PCN No#: 071521-1

PCN Title: Additional new lead frame for SOT-523 Package

PRODUCT CHANGE NOTICE

Table A - Lead frame comparison and marking code comparison

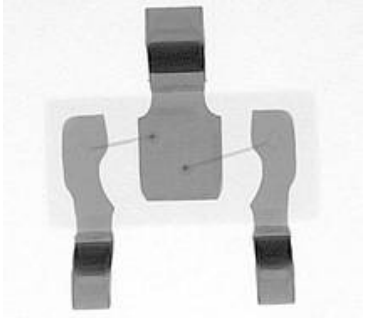
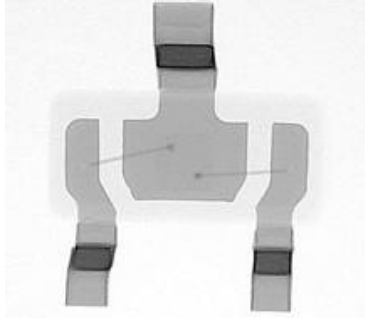
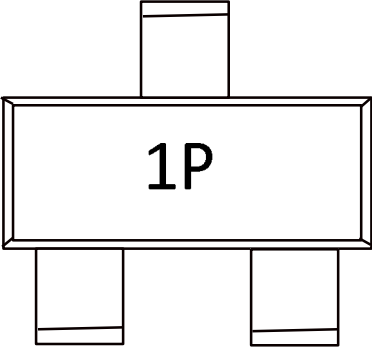
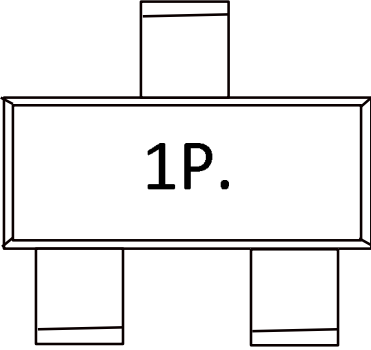
Notification Date	Implementation Date	Last Time Buy Ship Date	Change Type	PCN No
Jul 15, 2021	ASAP	N/A	Additional new lead frame	071521-1
TITLE				
Additional new lead frame for SOT-523 Package				
DESCRIPTION OF CHANGE				
To make our lead frame more compatible of different part structures, MCC will add a new design of lead frame for SOT-523, this change will not affect any reliability of the parts and there is no need to make any adjust of the solder pad.				
IMPACT				
No change in datasheet electrical parameters and product performance. Table A: Lead frame comparison and marking code comparison.				
PRODUCTS AFFECTED				
Table 1: Affected Parts List				
WEB LINKS				
Terms And Conditions:	https://www.mccsemi.com/Home/TermsAndConditions			
For More Information Contact:	https://www.mccsemi.com/Contact/Index			
Products:	https://www.mccsemi.com/ProductCategories			
DISCLAIMER				
Unless a MCC Sales representative is contacted in writing within 30 days of the posting of this notice, all changes described in this announcement are considered approved.
